IN THE MATTER OF Application CRC242267 to
undertake erosion and inundation protection works at
Southshore and South New Brighton Park.

Addendum to Section 42A Officer's Report

Report of Melanie Jane Burns

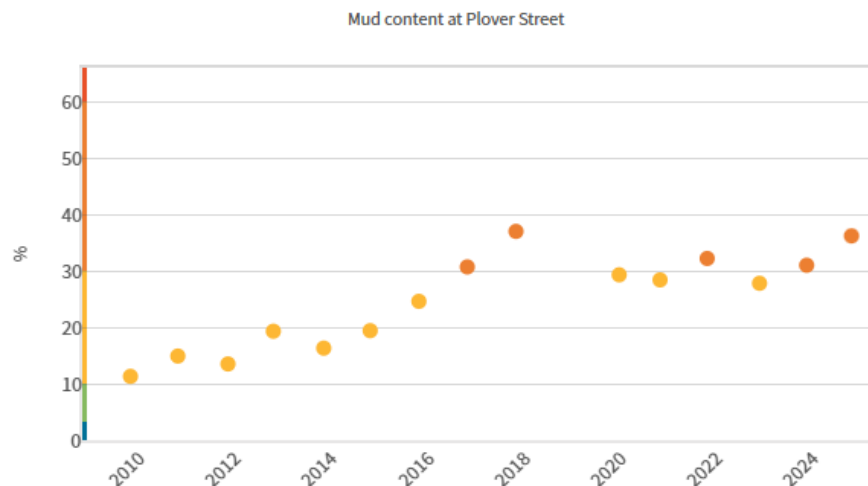
43. Also, the ability of seagrass beds to up-regulate during low tide depends on not only the duration of emergence, but whether suspended sediments settle out and smother primary producers (Drylie et al., 2018). Monitoring of estuarine sediment grainsize by CCC at Plover Street¹ shows an increasing proportion of mud content in the surface sediment (see graph below) over the last 15 years.

44. Seagrass beds have shown some resilience to increases in mud content (up to ~33%). While areas of high mud content (>39%) are likely to lead to degradation and loss of seagrass habitats and the expansion of unvegetated soft sediment habitats (Flowers et

- al., 2023b). The mud content at Plover Street in 2025 was recorded around 36%. Therefore, it is possible that the seagrass beds at Plover Street (Southshore) are already experiencing stress, which could reduce their ability to up-regulate with increasing SLR.
